Approved Ground Floor Plan - 2016/3133/P

project: **KAZU 和**

drawing:
Approved and Proposed
Ground Floor Plan

dwg.no: 17.227.104

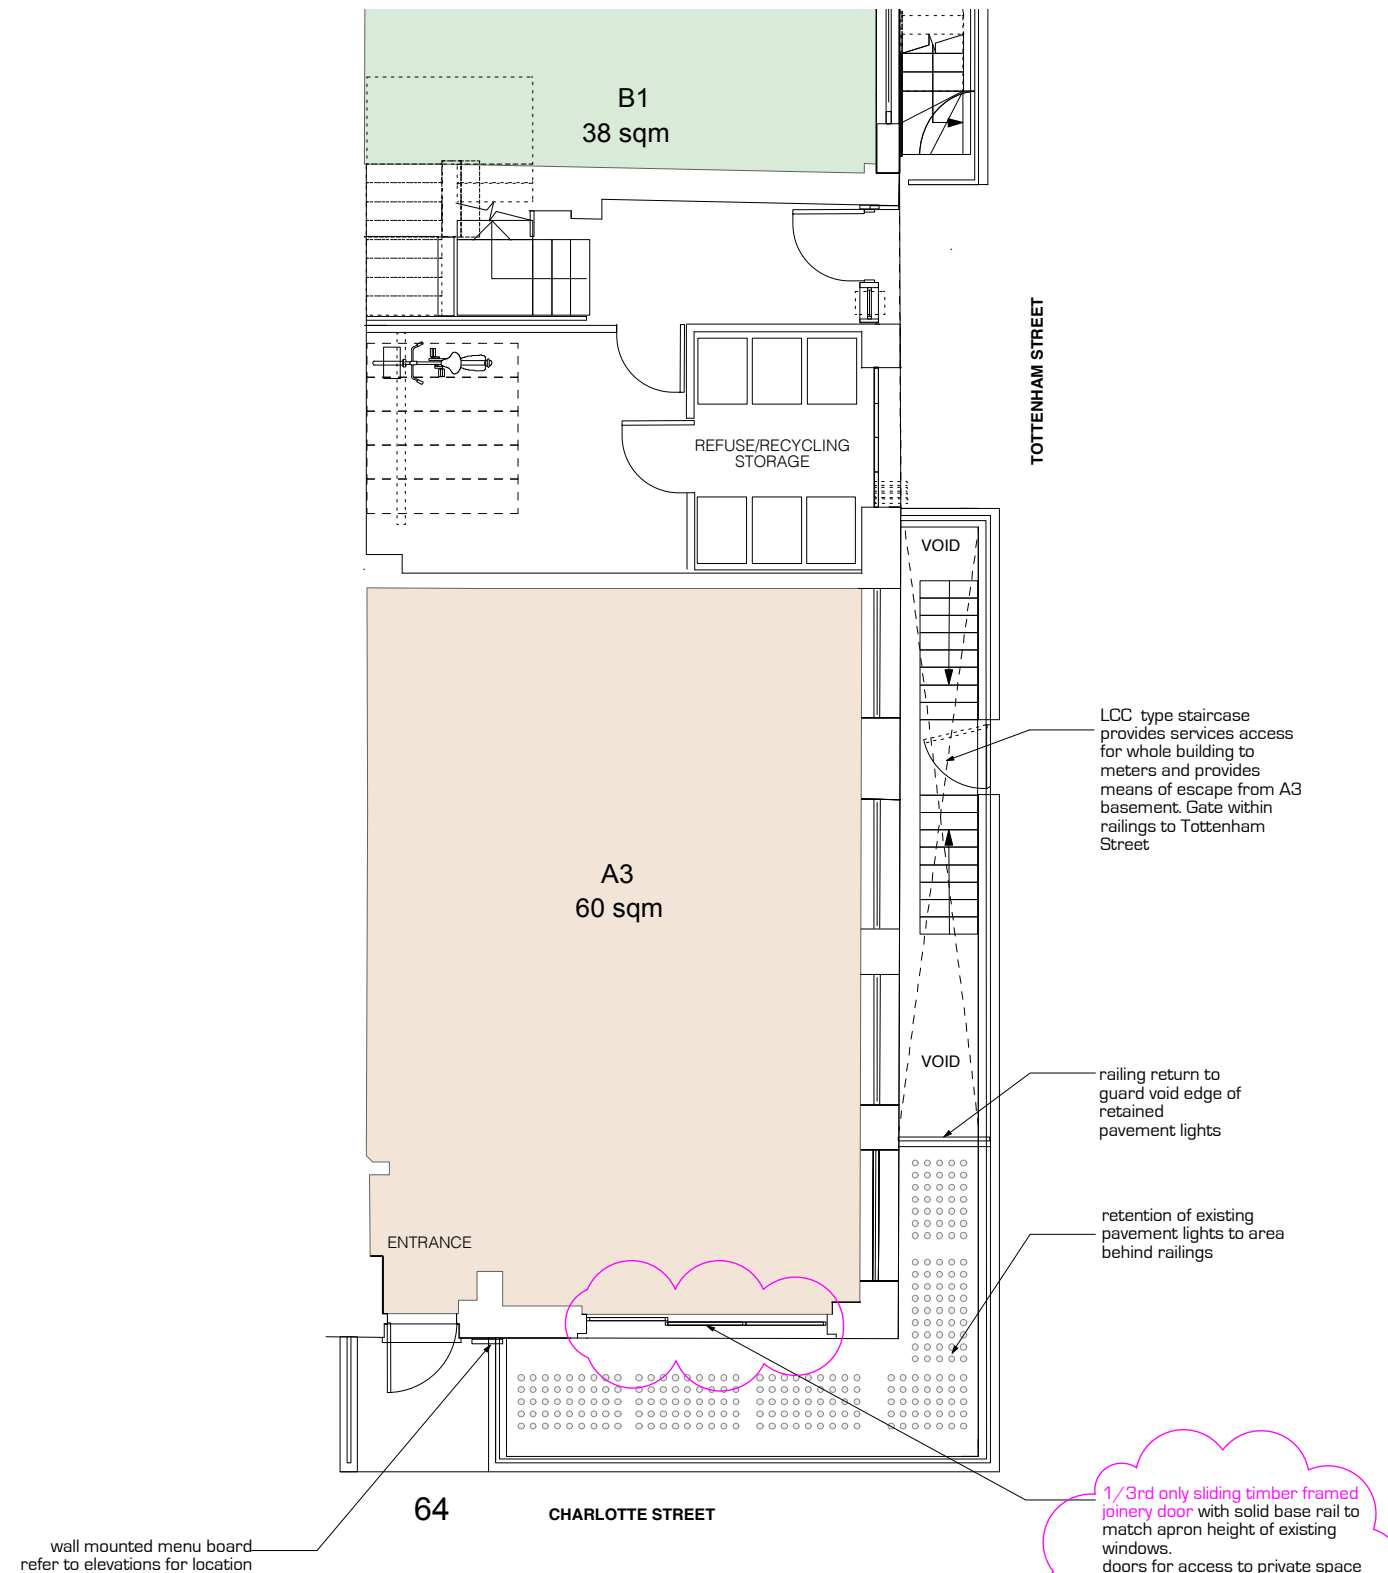
1/3rd only sliding timber framed joinery door with solid base rail to match apron height of existing windows. doors for access to private space behind railings and natural ventilation. joinery to be gloss painted 'heritage colour' from F&B or similar" on ogee sections to match existing
